Point Beach Nuclear Plant, Units 1 and 2  
Dockets 50-266 and 50-301  
Renewed License Nos. DPR-24 and DPR-27

License Amendment Request 261  
Extended Power Uprate  
Response to Request for Clarification

#### LICENSE AMENDMENT REQUEST 261 EXTENDED POWER UPRATE RESPONSE TO REQUEST FOR CLARIFICATION

**Figure 14-1: Point Beach Units 1 and 2 External Support Bracket Geometry**

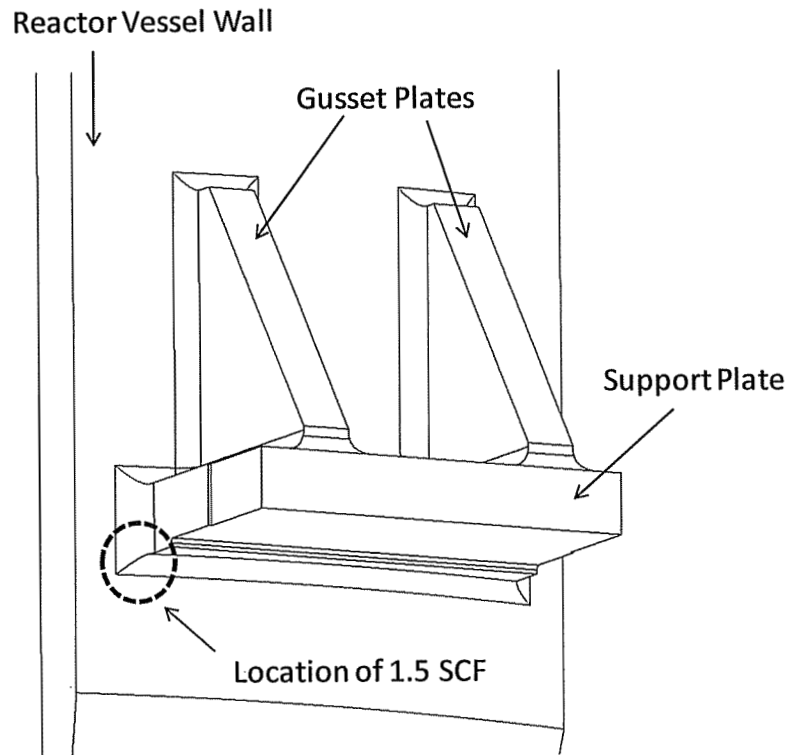
*The geometry that the SCF of 1.5 vs. 3.27 applies to is not clearly understood as well as whether a weld in that location is involved.*

The geometry of the external support brackets is shown in Figure 14-1. The external support brackets consist of two gusset plates and a support plate. The location where the 1.5 SCF has been applied is indicated in Figure 14-1. The external support brackets are attached to the vessel wall using a full penetration, double groove weld configuration as shown in Figure 14-2. The support plate has 45° grooves machined on each side. One side of the support plate is welded to the vessel. Machining is performed from the remaining groove until sound metal and weld is reached, and then the other side is welded. Finally, the fillet between the horizontal surfaces of the support plate to vessel wall are final machined to 1.125 inches, and the fillet between the vertical surfaces of the support plate to vessel wall are final machined to 2.0 inches. The solid model in Figure 14-1 does not include the blending of the 1.125 inch and 2.0 inch fillets at the corners.
